# UNITED STATES PATENT AND TRADEMARK OFFICE

APPLICATION NO.	FILING DATE	FIRST NAMED INVENTOR	ATTORNEY DOCKET NO.	CONFIRMATION NO.
09/665,668	09/20/2000	Larry B. Gray	JJI-49	5527
7590 09/30/2009 Audley A. Ciamporcero, Jr., Esq. Johnson & Johnson One Johnson & Johnson Plaza New Brunswick, NJ 08933-7003			EXAMINER BUI, VY Q	
			ART UNIT 3773	PAPER NUMBER
			MAIL DATE 09/30/2009	DELIVERY MODE PAPER

**Office Action Summary****Application No.**

## DETAILED ACTION

**FIG. 2**

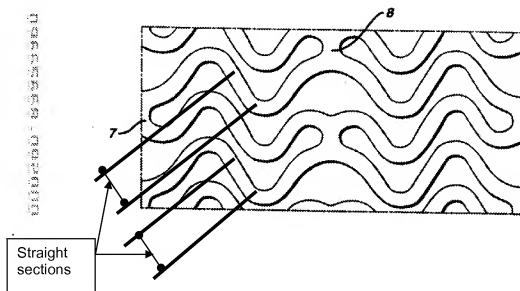
At least Kleshinski-'765's stent 14 includes curved section where struts 6 are bent around pins 50 (Fig. 13). It is clearly shown in Fig. 13 that Kleshinski-'765's stent 14 includes straight sections where struts 6 abut each other along a distance between two pins 50. However, Fig. 2 and 6 (Fig. 2 is reproduced below) of the present invention also show curved and straight sections, therefore the stent of the present invention includes curved and straight sections as well as Kleshinski-'765's stent.

Because Kleshinski-'765's stent and the stent of the present invention include both straight sections as well as curved section, therefore, the struts of both Kleshinski-'765's stent and the stent of the present invention are considered as serpentine struts as recited in the claims.
